Amendments to the drawings**In the Drawings:**

REMARKS

FIG. 1
(Prior art)

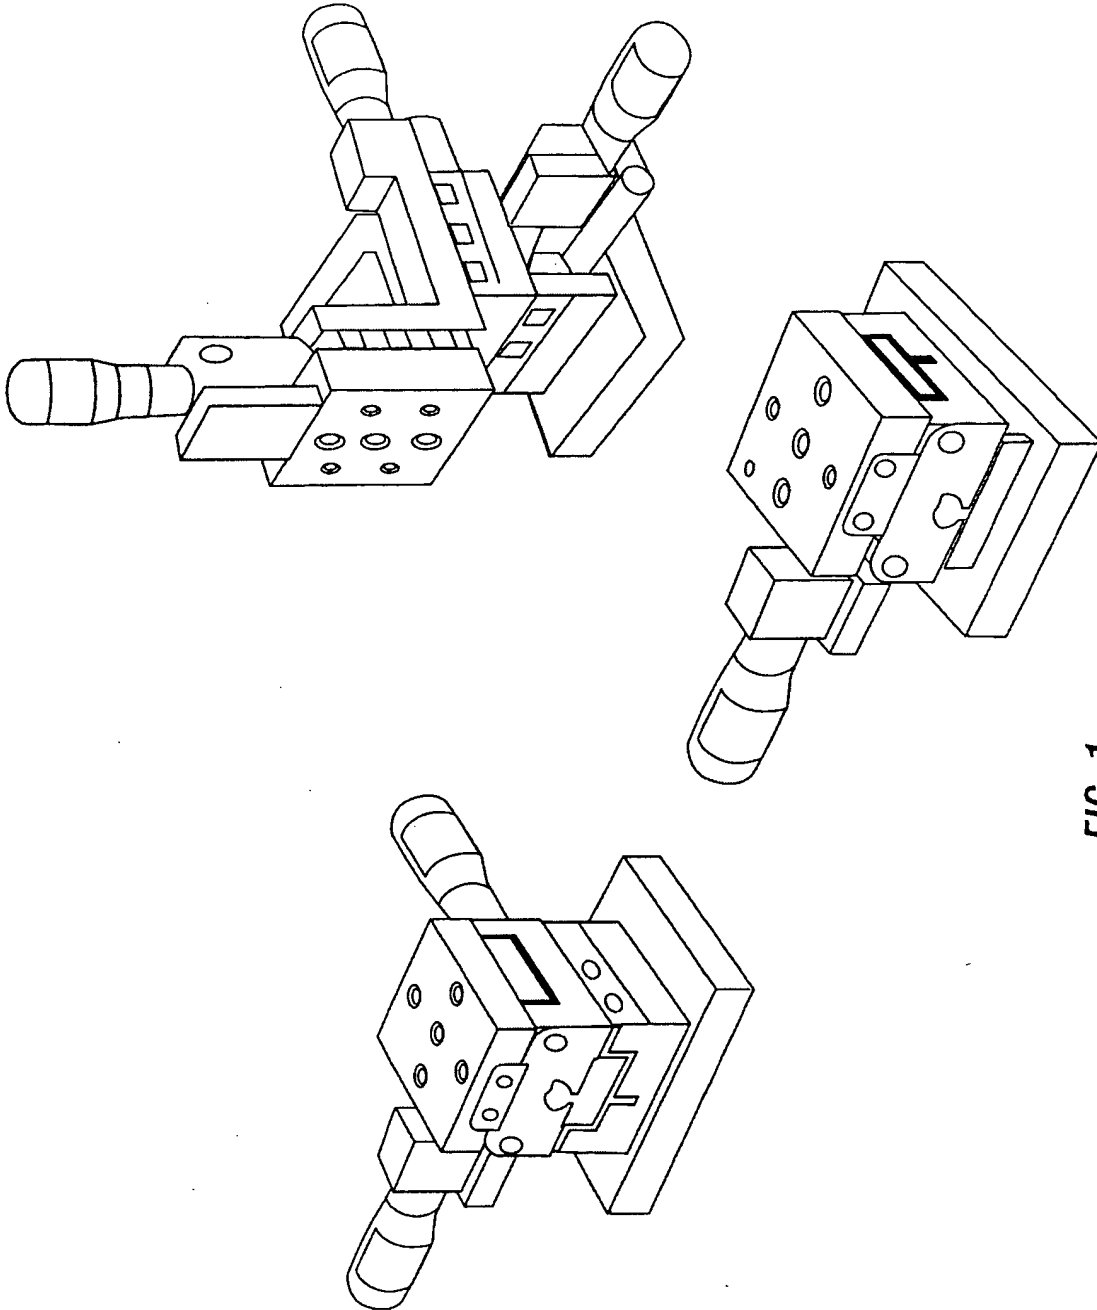
Proposed amendments to FIG. 1-4 and 7 are provided herewith. Enclosed are 5 sheets of mark-up copies and 5 sheets of clean as-amended copies, wherein FIG. 1-3 have the text “(Prior art)” added, FIG. 4 has the text “(Background art)” added, and FIG. 7 has the reference 20 replaced with the reference 68.

We respectfully ask entry of the proposed amended versions of FIG. 1-4 enclosed herewith. As filed, FIG. 1-3 inadvertently failed to include the text “(Prior art)” and FIG. 4 inadvertently failed to include the text “(Background art).” These amendments will bring the figures into conformity with the text in paragraphs [0014]-[0017] of the specification.

Added

FIG. 2

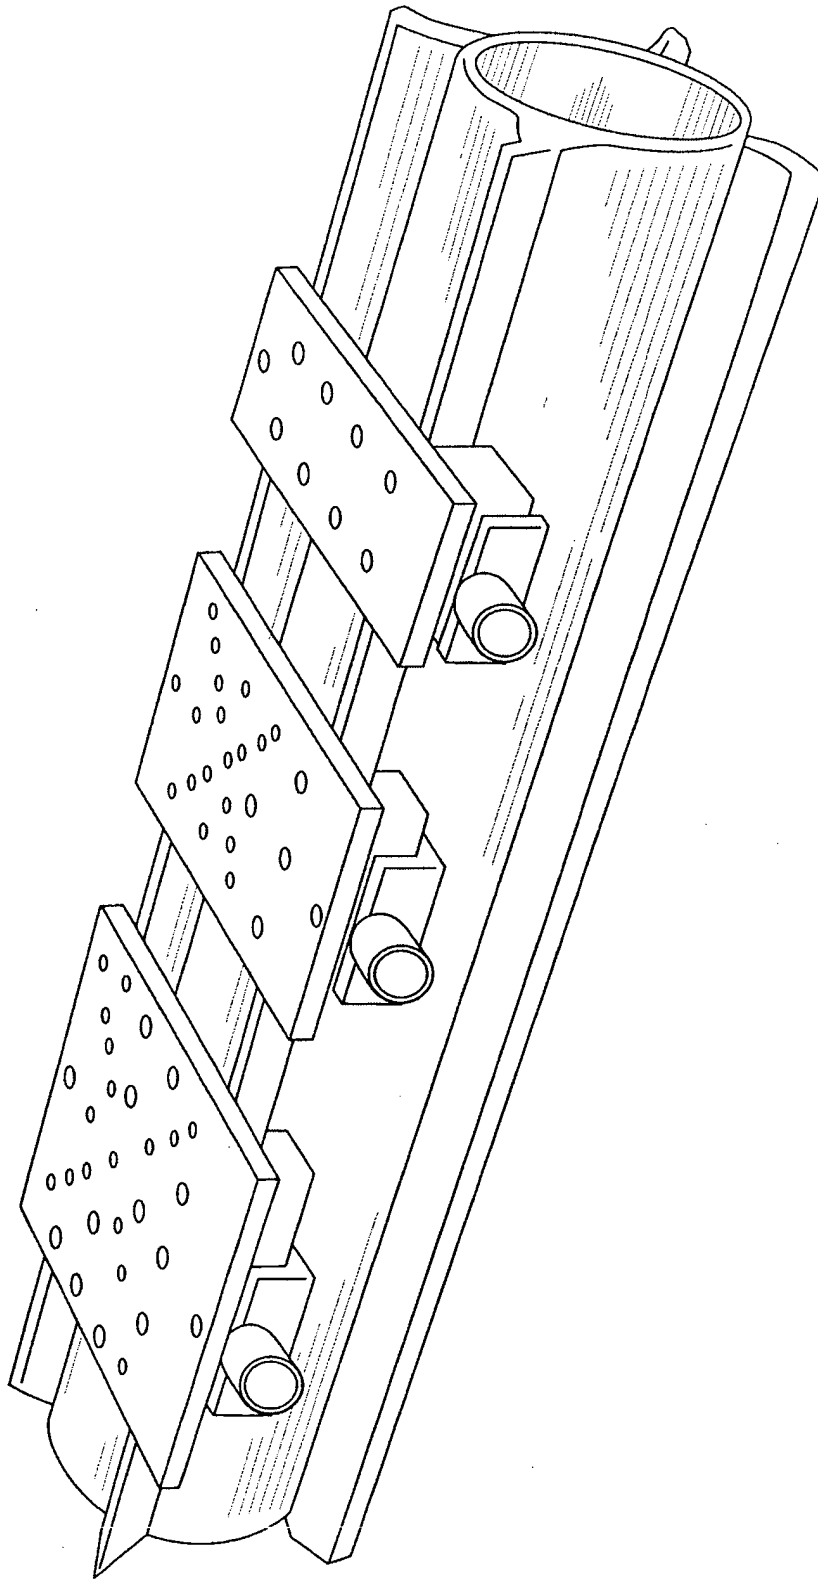
Turning now to claim 4, it recites “*a plurality of said stages and at least two said stages include a same said first piece and share a same said digital scale.*” FIG. 2 (Prior art) clearly shows multiple stages sharing a mount, thus the mechanical aspects here would be understood by one of ordinary skill in the art. FIG. 5a-b, 6 and 7 show a digital scale, thus it would be understood by one of ordinary skill in the art what a “*same said digital scale*” is. And we further note that 37 CFR 1.83(a) does not require that drawings odiously show every possible straightforward variation feature of an invention, rather this states that “*applicant ... is required to furnish a drawing ... where necessary for the understanding of the subject matter sought to be patented.*” Respectfully, we urge that Applicant has shown what is necessary for one of ordinary skill in the art to understand claim 4.

What has been missed here, however, is the overall context and the tension between common spoken English and the need for antecedent basis in claims. Claim 4 (now) recites “a plurality of said stages and at least two said stages include a same said first piece” (underlining added). In common spoken English one would simply say that two of the stages include the same first piece. We previously (in claim 1) introduced “a first piece” so it is our understanding under the antecedent basis rules that use of the phrase “said first piece” is required here in claim 4. Also, here we have multiple stages (each having a respective said first piece) and we need to introduce “a same said first piece,” which is one first piece that is common (the same) to two stages. By way of example, FIG. 2 shows three stages all sharing one first piece (the tubular appearing mount).

Added

FIG. 7
Rotary stage equipped with digital scale disk

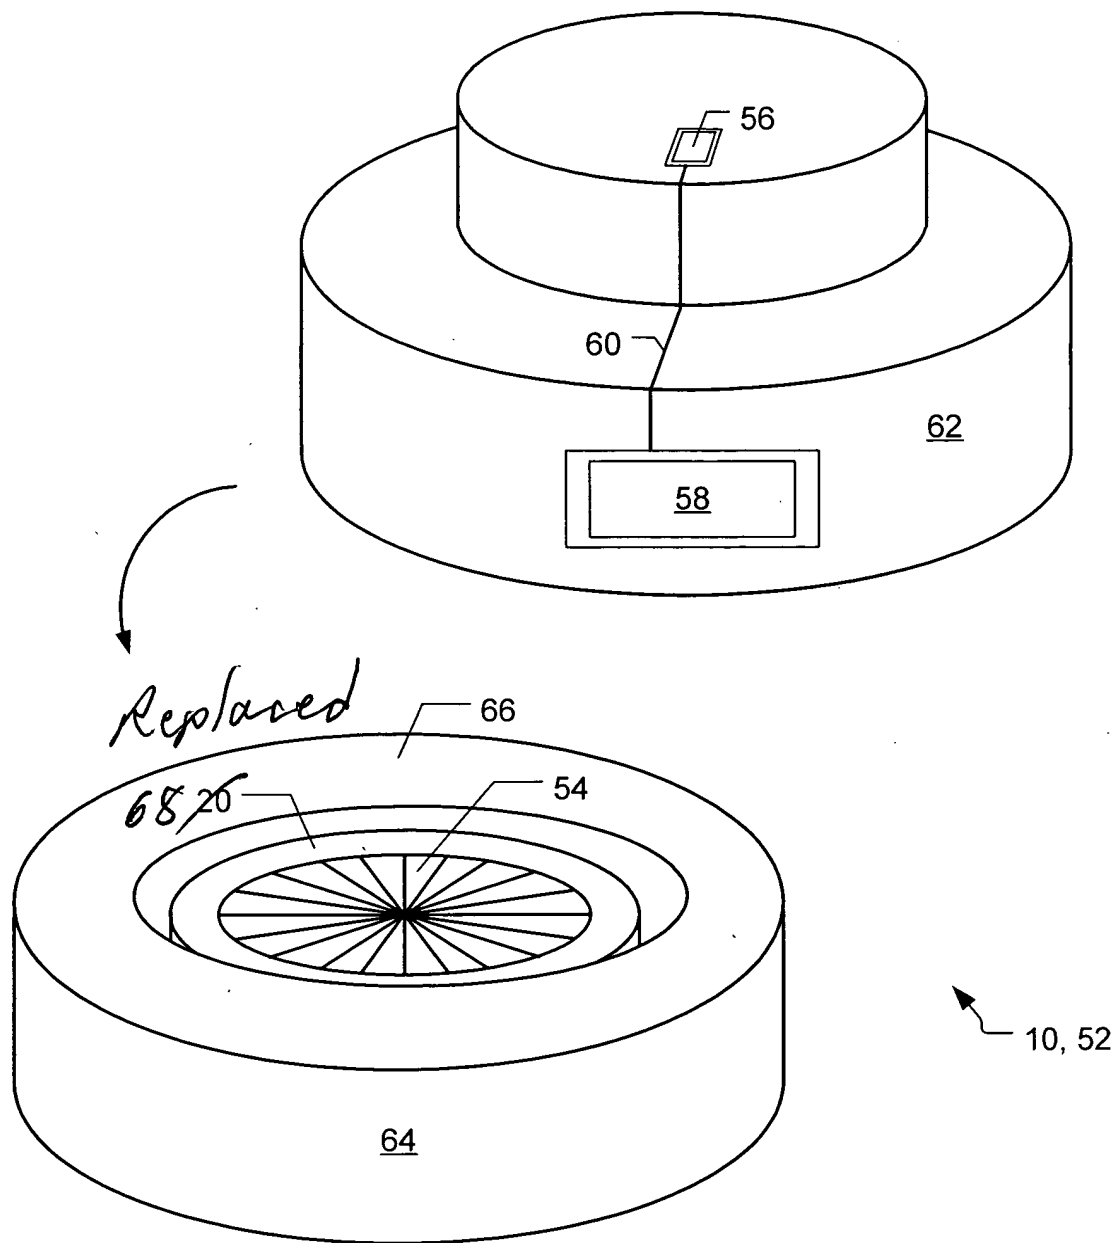
The Action here states, “*The drawings are objected to ... because they do not include the following reference sign(s) mentioned in the description: “68”*” This objection is well founded and corrective amendment is made herein.
